Project	IEEE 802.16 Broadband Wireless Access Working Group < http://ieee802.org/16 >	
Title	Soft Handover and Fast BS Switching Procedure	
Date Submitted	2004-06-25	
Source(s)	Hang Zhang, Mo-Han Fong, Jianglei Ma, Peiying Zhu, Wen Tong Nortel Networks	mhfong@nortelnetworks.com
	Itzik Kitroser, Yigal Leiba, Yossi Segal, Zion Hadad Runcom Technologies	itzikk@runcom.co.il
	Sohyun Kim, Changhoi Koo, Jaewon Cho, Seung Joo Maeng, Myung-Kwang Byun, Jungwon Kim Samsung Electronics	binde.kim@samsung
	Mary Chion, Jing Wang ZTE	mchion@ztesandiego.com
	Min-Sung Kim KT	cyberk@kt.co.kr
Re:	IEEE P802.16e/D3-2004	
Abstract	In this contribution, the soft handover and fast BS switching mechanism is proposed	
Purpose	Review and Adopt the suggested changes into P802.16e/D3	
Notice	This document has been prepared to assist IEEE 802.16. It is offered as a basis for discussion and is not binding on the contributing individual(s) or organization(s). The material in this document is subject to change in form and content after further study. The contributor(s) reserve(s) the right to add, amend or withdraw material contained herein.

Figure E.12—Example Soft HO (Active BS set Update: Add)

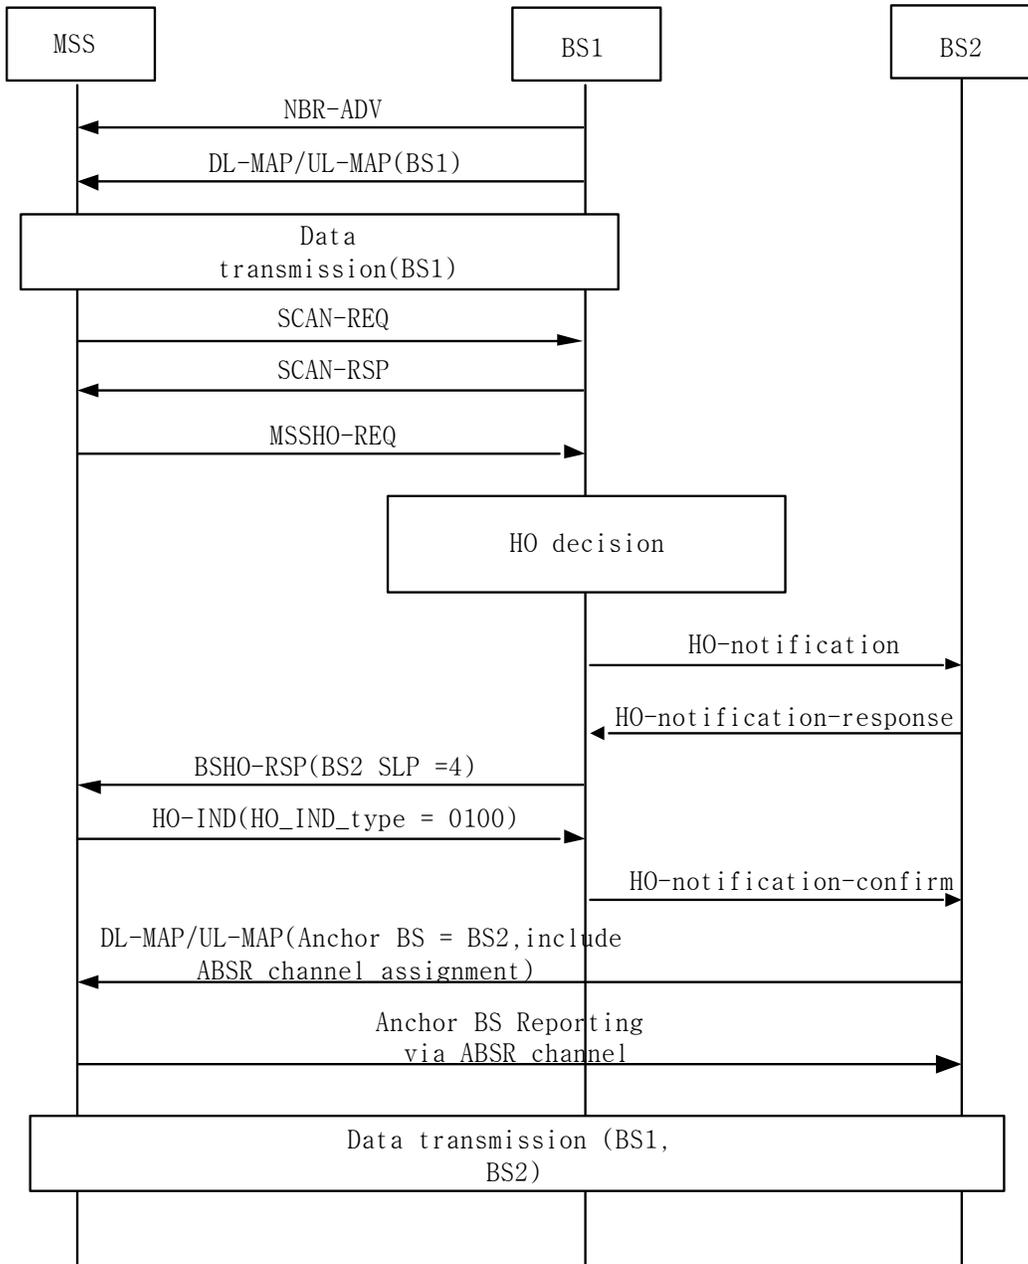
[Add the following call flows to Appendix E]
